Addendum #2

Issued February 29, 2024

Structural Mechanical Electrical Addendum No. 01

EXP Project: ALL-23010629-A0 HWDSB Glendale

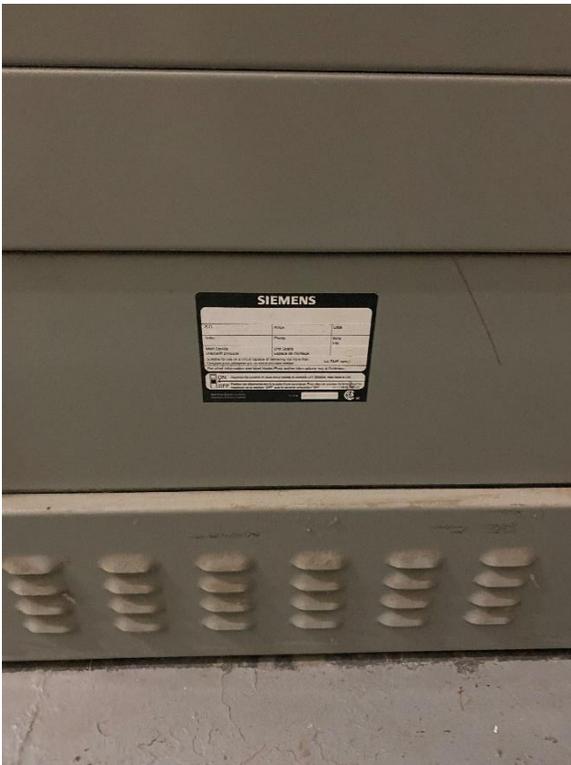
Please provide name plates/photos of existing panels 'LP - L', 'DP - A', 'HVD - A', 'PNL - U', 'PNL - V', 'HVD - B'.

Answer 1:

'LP-L'

'DP-A'

'HVD-A'

'PNL-U'

'PNL-V'

'HVD-B'

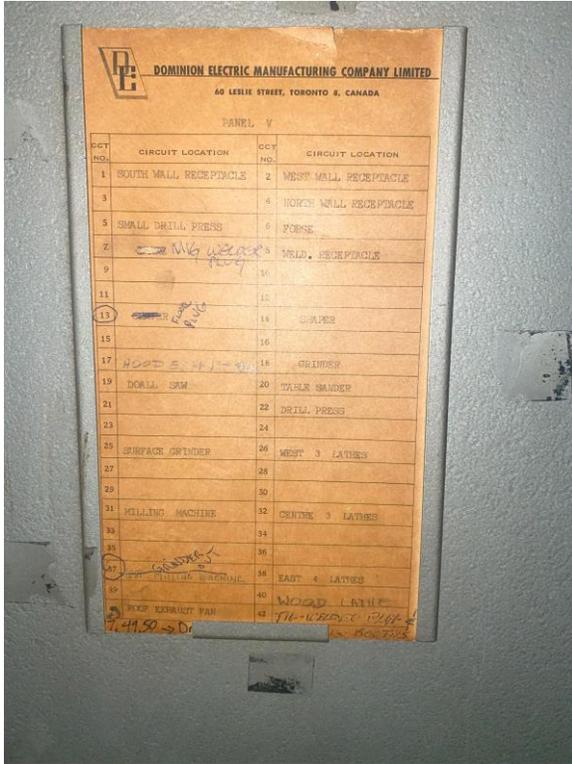
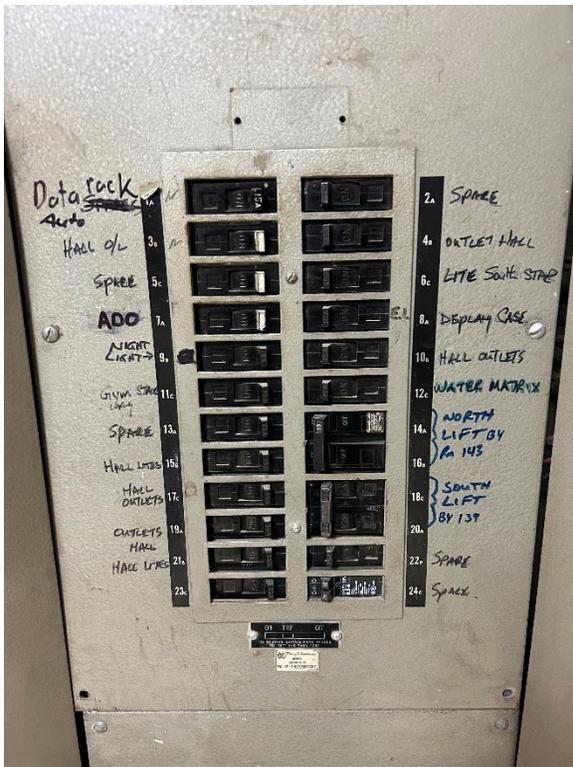
Note #5 on the drawing E2.1 says to provide separate price for upgrading panels 'PNL – U', 'PNL – V' and 'DP – Q'. Please provide more information like panel schedules, feeder sizes if we have to change the feeders.

PNL-U' Refer to Answer 1.

'PNL-V'

'DP-Q'

TYP. DETAIL - NEW SLAB ON GRADE AND MECHANICAL PAD AT BOILER ROOM
 SCALE: 3/4" = 1'-0"

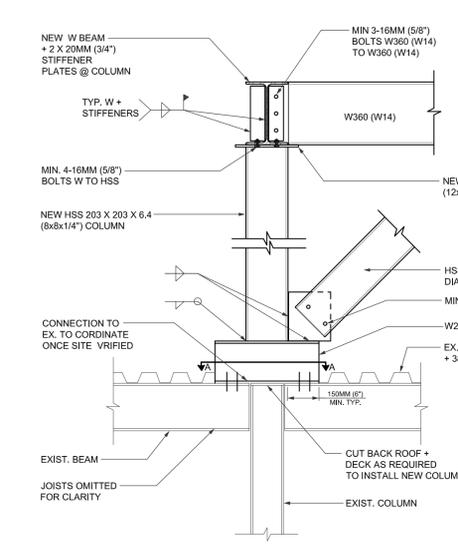
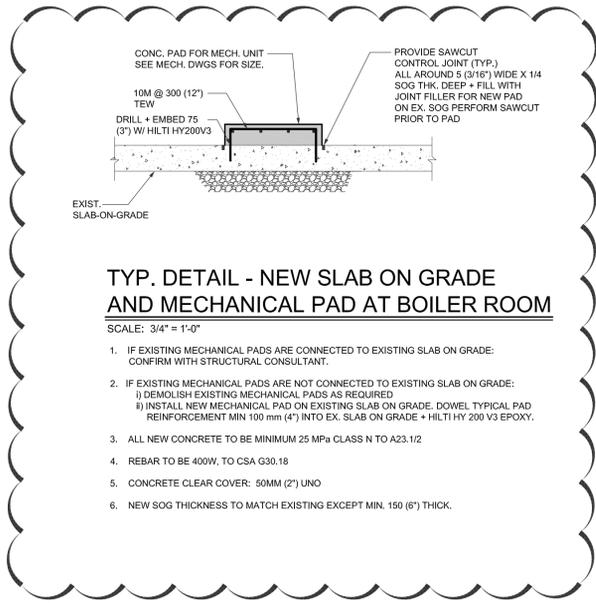
- .3 **GN-012CS – concrete anchors, inserts, bolts – typical notes added**
 - .4 **Typical detail – new slab on grade and mechanical pad at boiler room**

- .1 **Revised note 1 – if existing mechanical pads are connected to existing slab on grade, contractor shall confirm approach with structural consultant**

- .2 **Note 7 deleted – existing mechanical pads are not connected directly to slab per correspondence from contractor**
 - .3 **New slab on grade removed – detail revised to show connection to existing slab on grade only**

- .4 **Sawcut location revised**
2. **Drawing M0.2**
 - .1 **Mechanical general specifications training scope of work item 1.2.N revised to clarify training hours:**

R-001

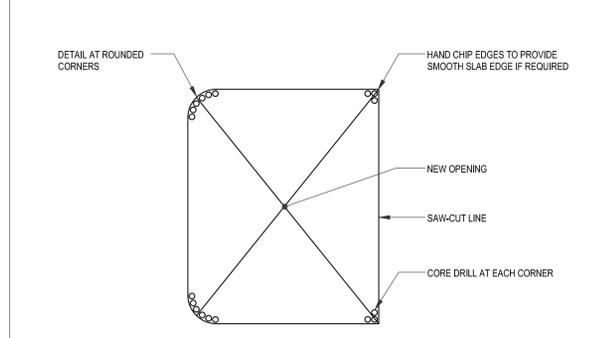
1. **Drawing S1.1**
 - .1 **R-001 – Detail for cutting a new opening through existing concrete slab – added**
 - .2 **R-003 – Structural guidelines for drilling, cutting and coring through existing concrete structure – added**

- NOTES:
- MARK OUTLINE OF NEW OPENING ON EXISTING SLAB.
 - CORE DRILL HOLES AT EACH CORNER.
 - SAW-CUT BETWEEN CORE-DRILLED HOLES, OR CORE DRILL ENTIRE PERIMETER. **DO NOT DRILL OR CUT BEYOND LIMITS OF THE OPENING DIMENSIONS.**

DRAWING #: MO.9

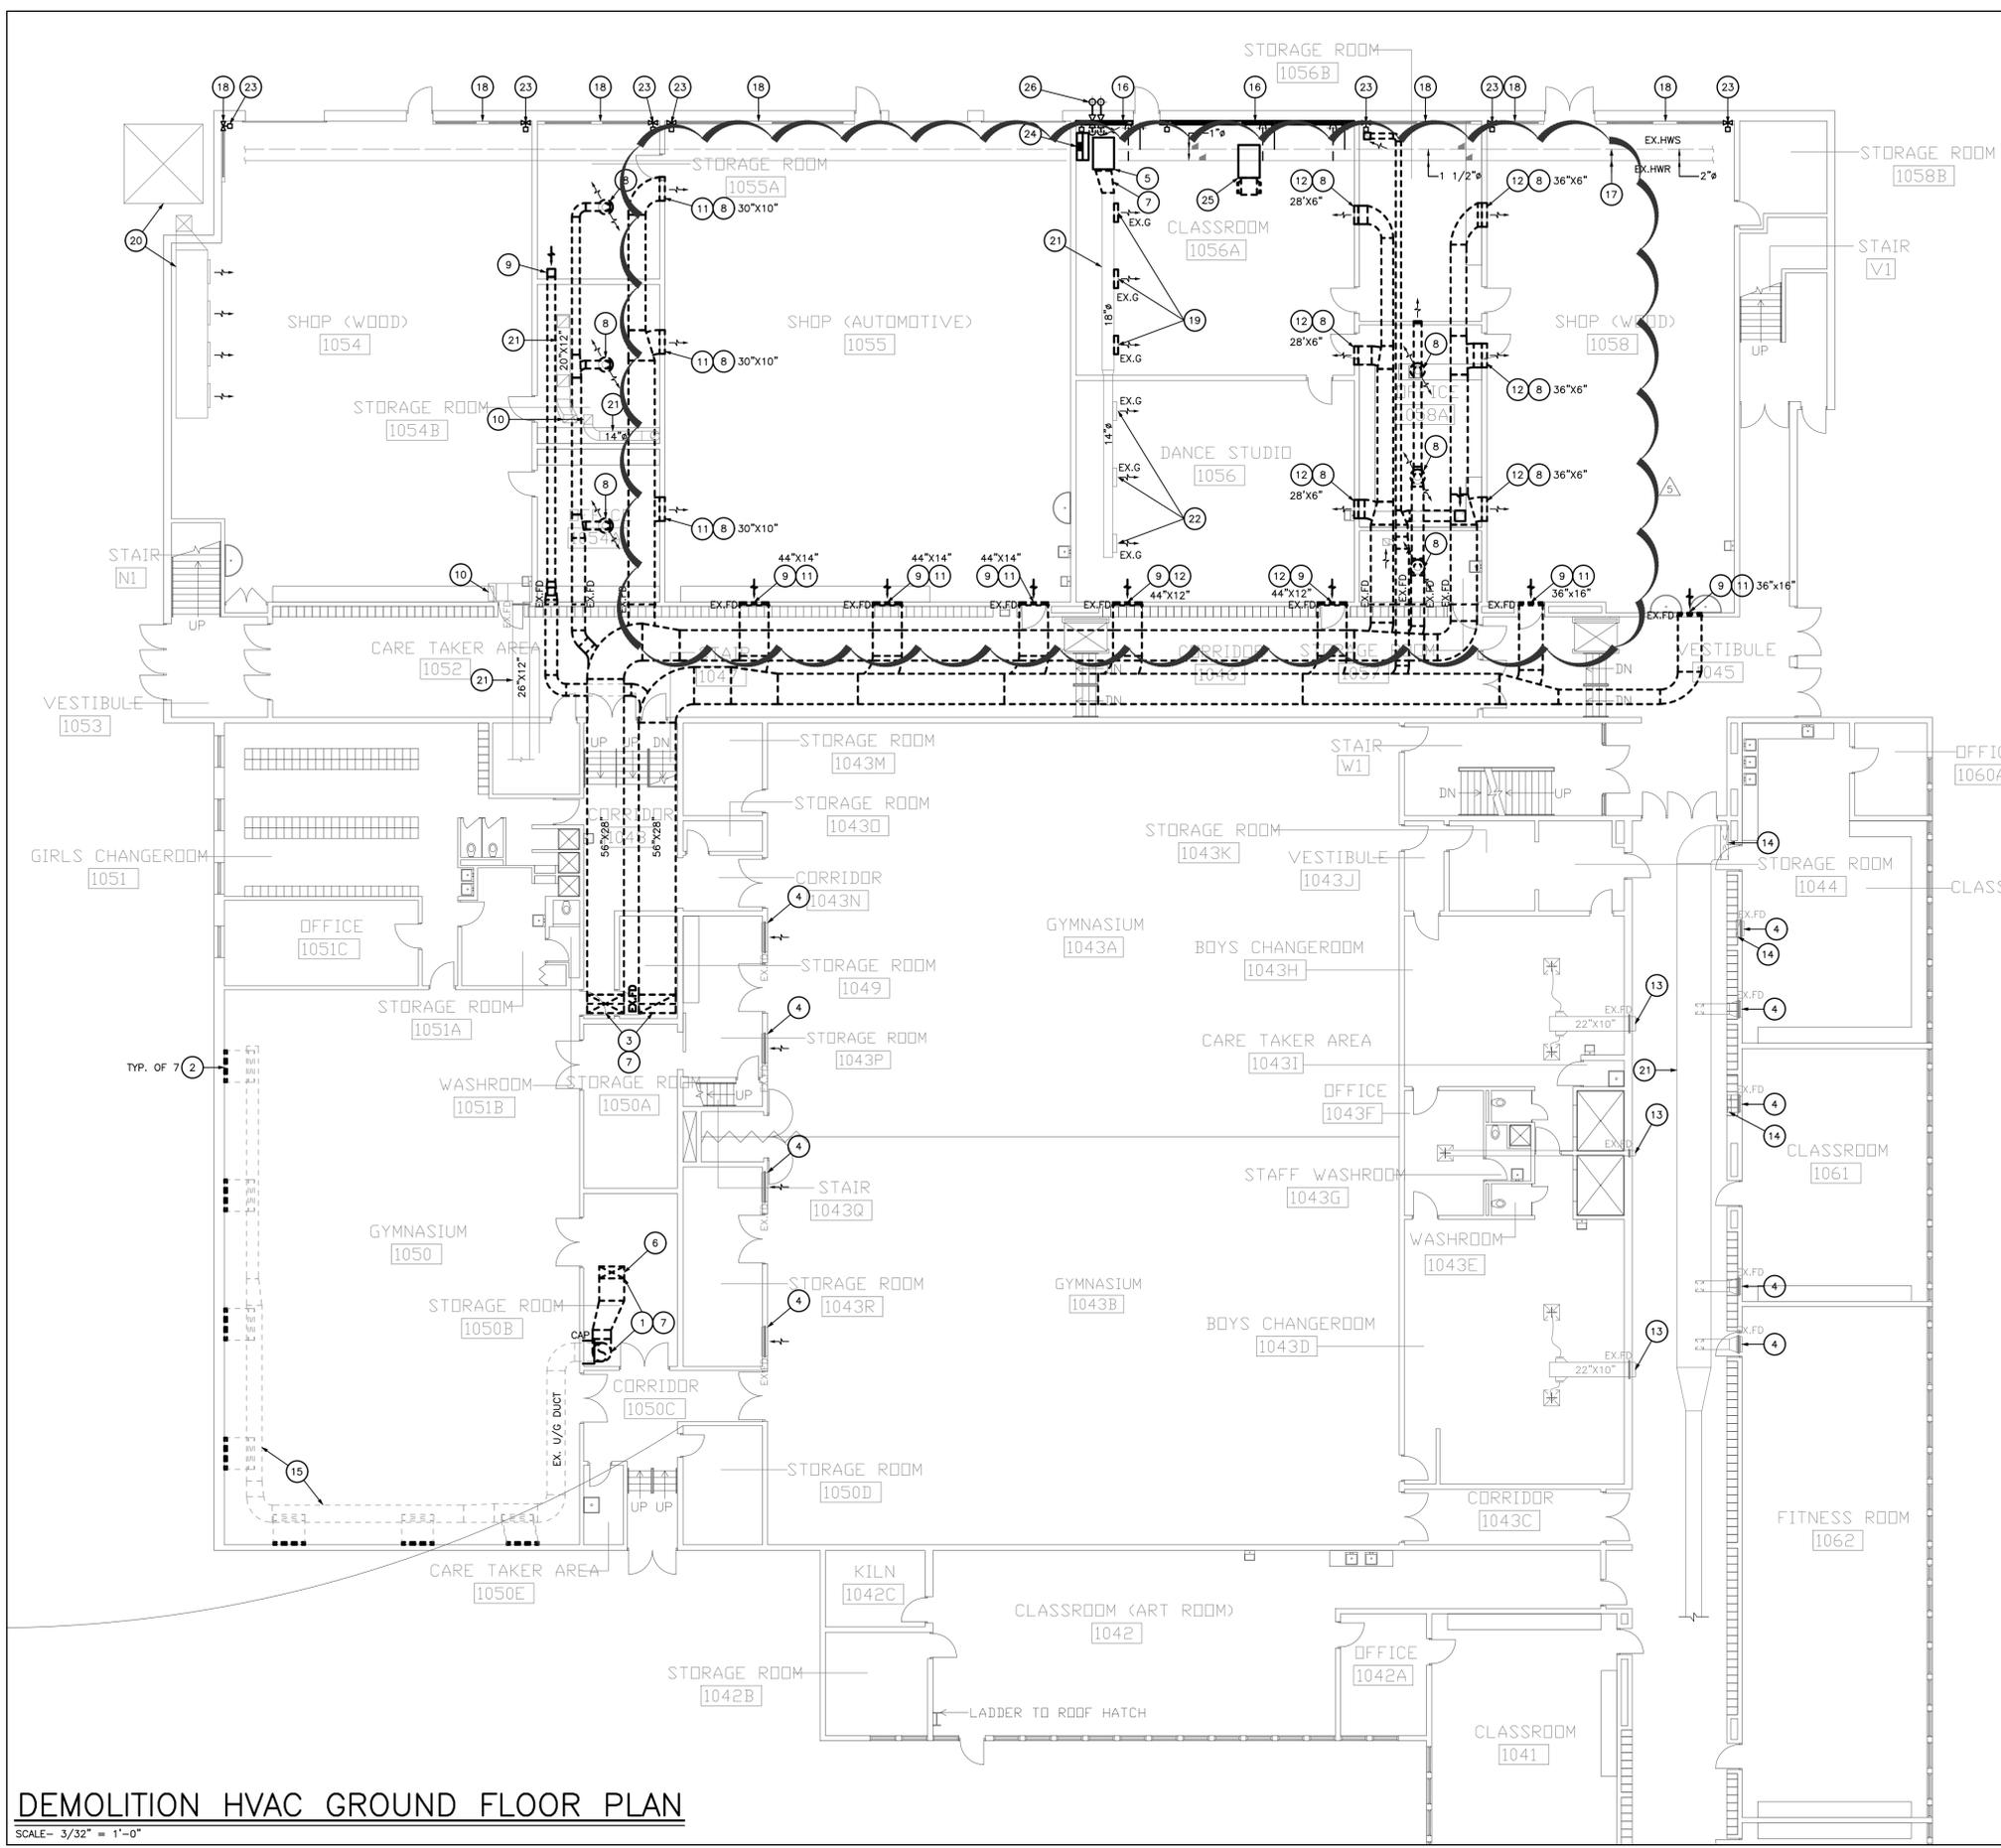
- .1 **4 hour training session for boilers & pumps**
 - .2 **4 hours training session for rooftop equipment & unit ventilators.**
3. **Drawing M0.9**
 - .1 **Controls BAS training scope of work item 19.A revised to clarify training hours:**

- .1 **Two (2) 4 hour training sessions totalling 8 hours are required under contract for BAS.**
4. **Drawing M1.1**
 - .1 **Existing grille dimensions added to drawing note 11 and 12. Note 11 indicates openings to be modified to suit new work. Note 12 indicates openings to be infilled. Refer to architectural drawings for details.**

A. PROVIDE MINIMUM OF (2) TRAINING SESSIONS, AND (4) HOURS FOR EACH SESSION, THROUGHOUT THE CONTRACT PERIOD...
B. THESE OBJECTIVES WILL BE DIVIDED INTO LOGICAL GROUPINGS...
